SERVICE BULLETIN

M-1043

NEW CYLINDER BASE GASKETS AND CYLINDER STUDS

Figure 2. New Cylinder Studs.

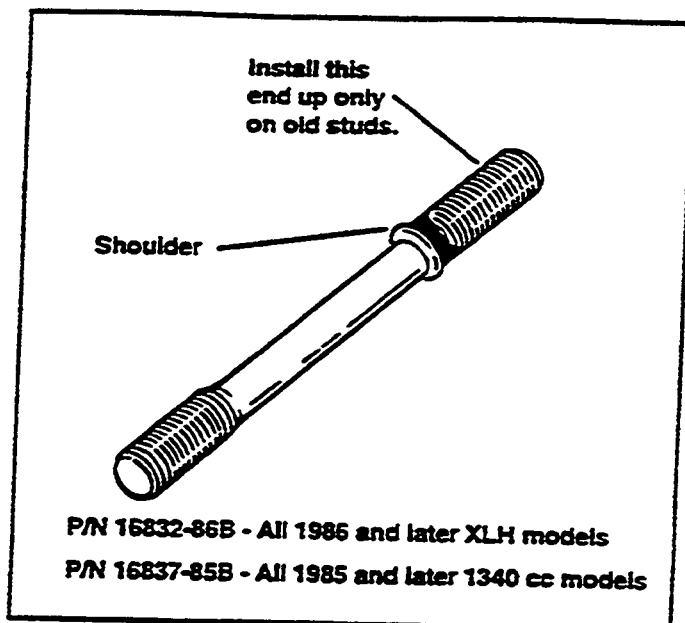
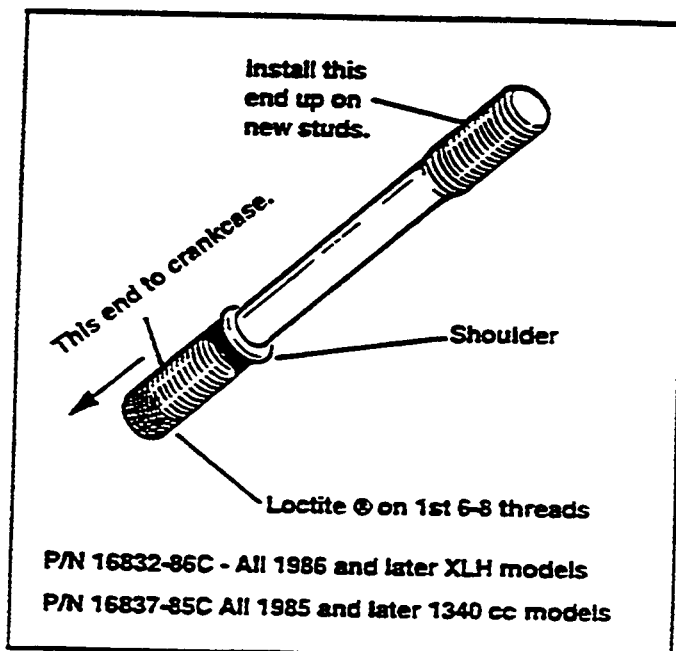
The new studs no longer provide an interference thread fit with the crankcase tapped holes. See Figures 1 and 2. Figure 1 shows the old cylinder stud, and Figure 2 shows the new stud.

See Figure 2. The new studs may be identified by the Loctite® applied to the first 6 - 8 threads on the shouldered end of the stud.

The new studs must be installed with the shouldered end down. Thread shouldered end into crankcase and tighten to 10 ft-lbs (13.6 Nm) torque. This torque should "bottom" the stud shoulder on the crankcase.

If new studs are removed and reinstalled, apply Loctite® 271, red, to the crankcase - end threads of the stud.

Figure 3. New Gaskets Installed On Crankcase

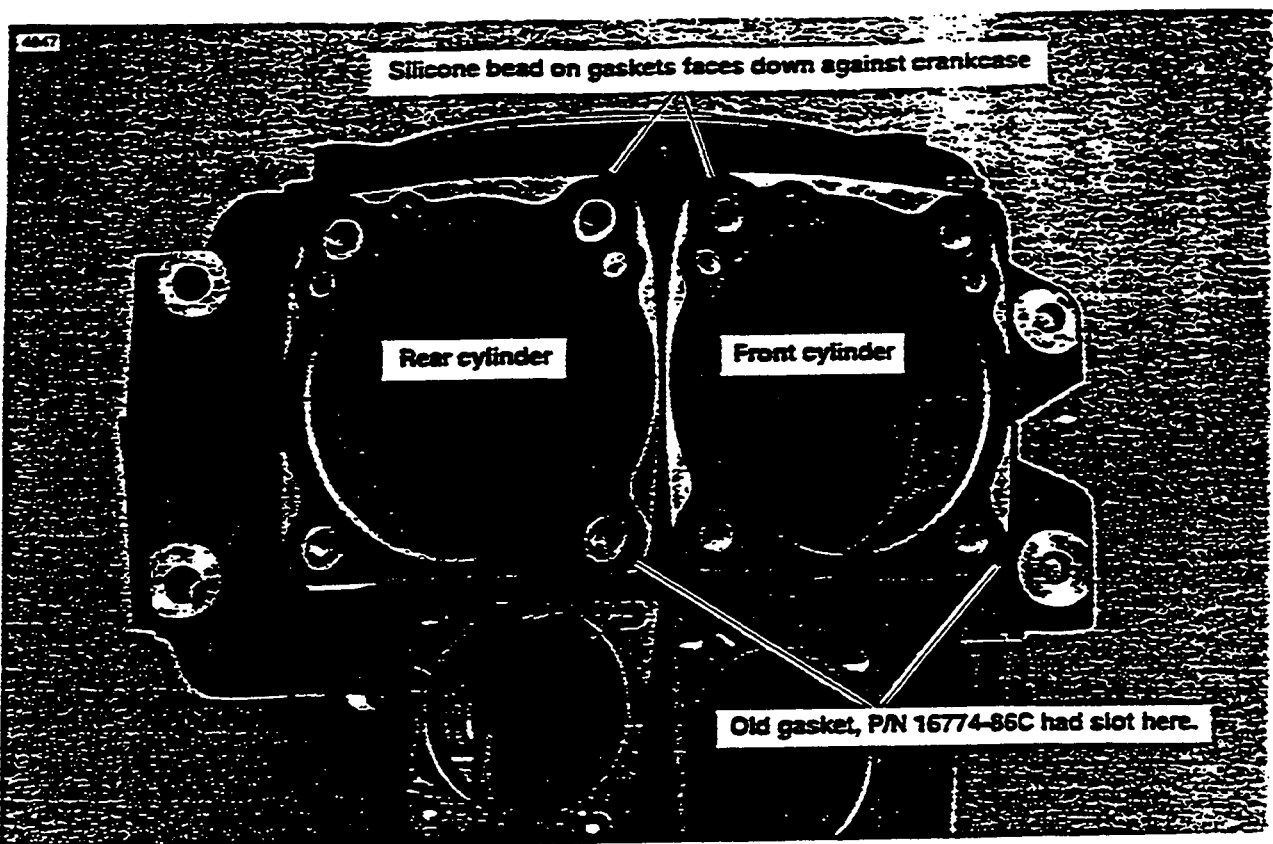
See Figure 3. The new cylinder base gaskets must be installed with the silicone bead facing the crankcase.

The new gaskets do not have the slot or cut-out at the hole as marked in Figure 3. Also, the new gaskets have a silicone bead on one side and are gray in color.

If your dealership has old cylinder base gaskets, Part No. 16774-86C, in stock, return them for credit. Order the new cylinder base gaskets, Part No. 16774-86D, to replenish your stock. See following "Credit Procedure" for details.
